RE: Revised BDAR Spatial Data –Tweed Sand Plant Expansion, Cudgen Tweed LGA (SSD-10398)

Attachment 1: Detailed BCD Comments – Revised Spatial Data Tweed Sand Plant Expansion, Cudgen

Figure 1. Area circled in red (Approved Riparian PCT 1235 within Phase 6 works) has not been included in the BDAR Direct Impacts on Vegetation calculations.

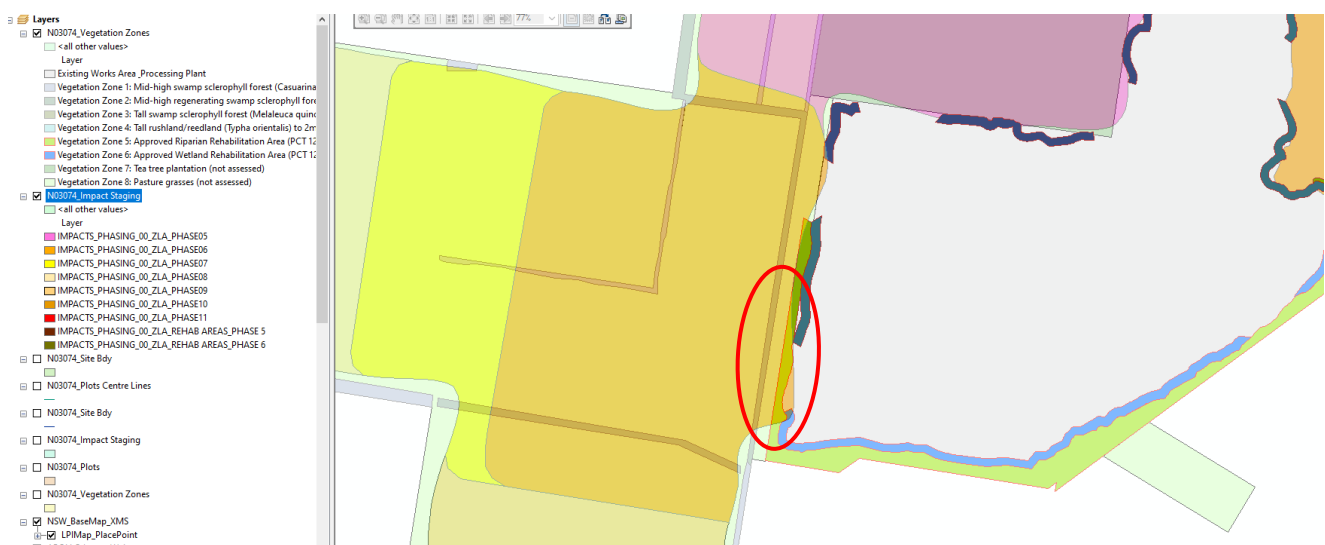
As described in Figure 1 below, some of the Approved Riparian Rehabilitation Area has not been identified as a loss despite the proposed expanded sand extraction area extending into it during the Phase 6 works.

The BDAR calculations should be reviewed and rectified once all our previous recommendations have been fully addressed as the implementation of our recommendations will affect the final extraction footprint.

Figure 3. Small areas of Vegetation Zone 1 adjoining the proposed haul road have not been calculated in the losses (circled in red). Also, the strip of Vegetation Zone 2 on the western boundary appears likely to be impacted by the future building and wash plant.

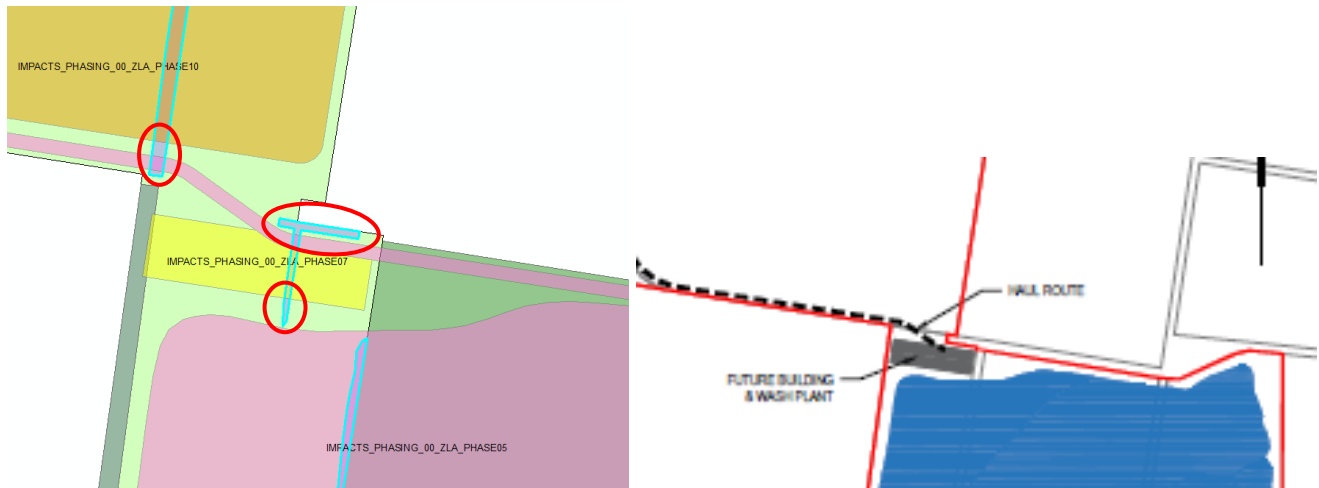
There are also areas that have not been included as a loss however they appear to be unlikely to be retained. For example, areas of Vegetation Zone 1 that are adjacent to the proposed haul road are not included in the loss calculations. Also, the strip of Vegetation Zone 2 appears likely to be

impacted by the future building and wash plant as shown in Figure 3 below and would also require protection and ongoing management.
